Eurocode 3 - Design of steel structures - Part 4-2: Tanks

This draft amendment is submitted to CEN members for enquiry. It has been drawn up by the Technical Committee CEN/TC 250.

This draft amendment A1, if approved, will modify the European Standard EN 1993-4-2:2007. If this draft becomes an amendment, CEN members are bound to comply with the CEN/CENELEC Internal Regulations which stipulate the conditions for inclusion of this amendment into the relevant national standard without any alteration.

Figure 1.2 — Local coordinate systems for meridional and circumferential stiffeners".

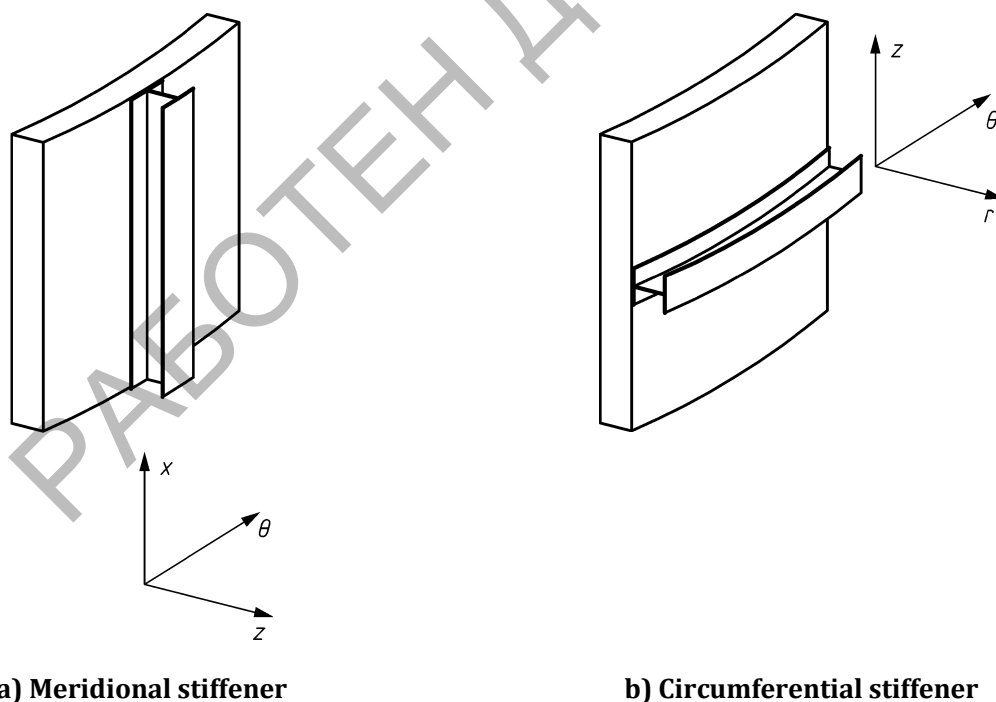
Replace Figure 1.3 with the following new Figure 1.2:

Figure 2.1 — Dimensions defined for Consequence Classes

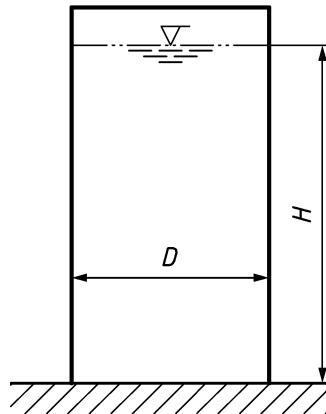
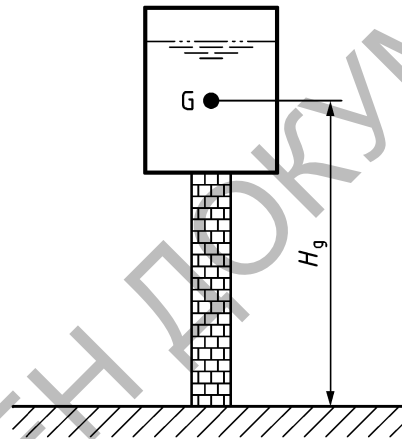
(4) The classification of flat-bottomed tanks that rest on the ground is based on the dimension U , which is related to the potential energy of the stored fluid.

where D is the tank diameter and H is the maximum depth of stored fluid (see Figure 2.1a)).
